# Imray Correction Notice ICC38-2

## Chart **C38** WGS 84

*Edition 2016*

*Below is a complete list of corrections issued since the 2016 edition of this chart was published.*

25 **Quiberon S**

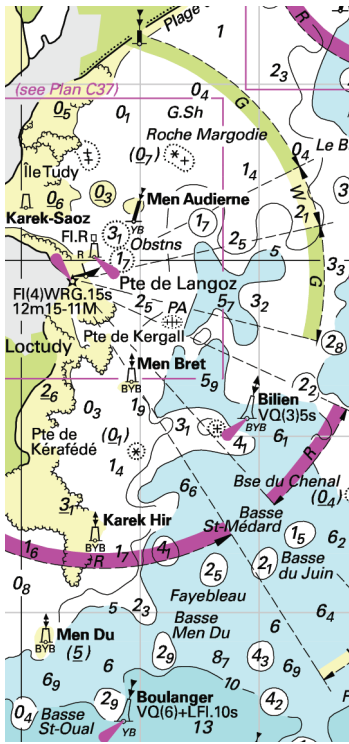
BRB isolated danger buoy **An Tréac'h** is now lit. Add legend FI(2)10s in 47°27'·92N 3°07'·20W (ILNW 506/20)
